PRODUCT / PROCESS CHANGE NOTIFICATION

PCN-000659

SX1276IMLTRT
SX1278IMLTRT

Qualification of Greatek Taiwan as a second source Assembly manufacturer for LORA and ISM products

SEMTECH Package Outline on SX1276IMLTRT/ SX1278IMLTRT (Carsem and Greatek)

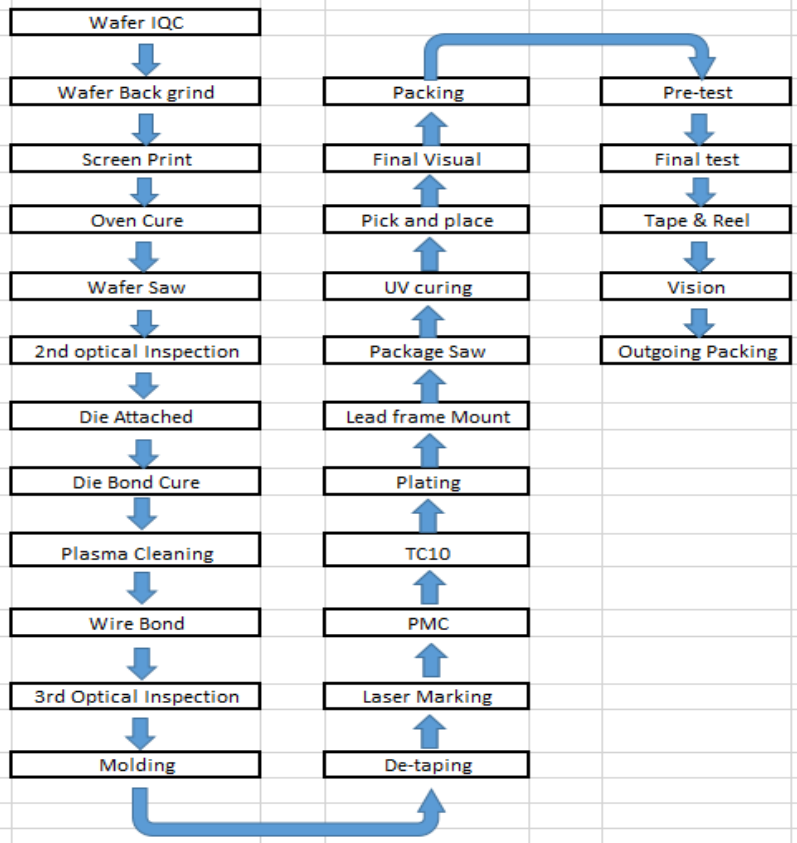
**No Change in
Package Outline.**

Assembly Process Flow (Carsem vs. Greatek)

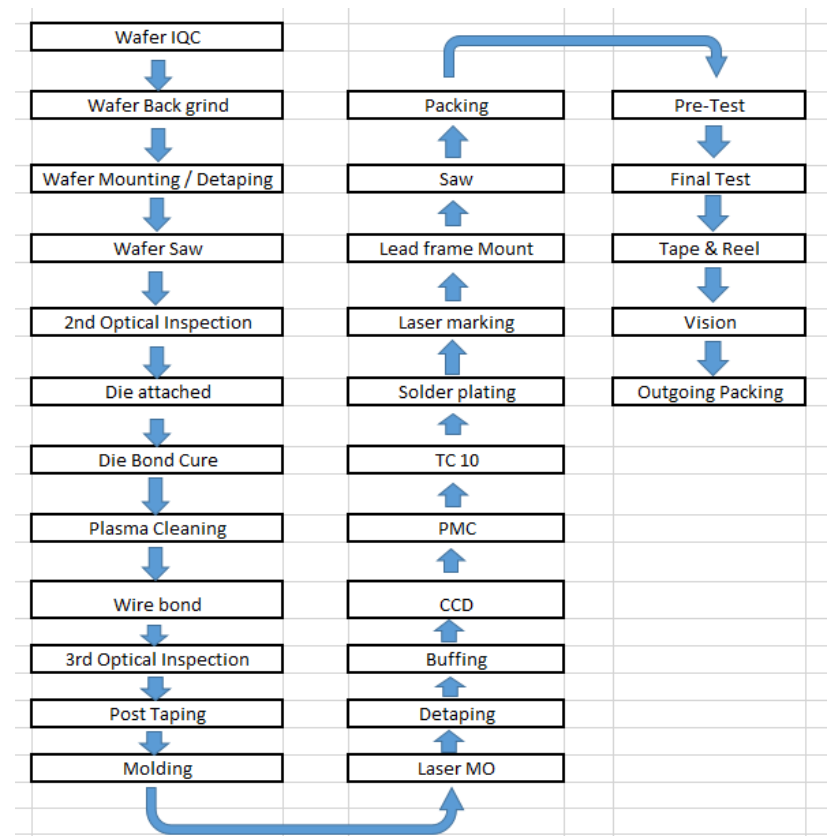
- No major Change in manufacturing Flow
- 1X IR reflow process step is applied in the assembly flow for both Carsem and Greatek.

Carrier tape 6x6 comparison (Carsem Vs Greatek)

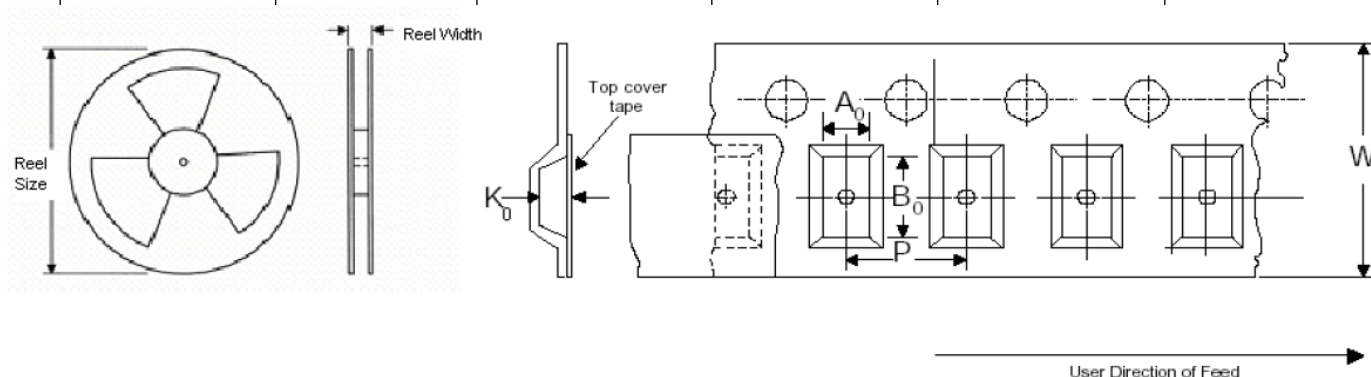
Carrier tape suppliers are different but critical dimensions are identical.
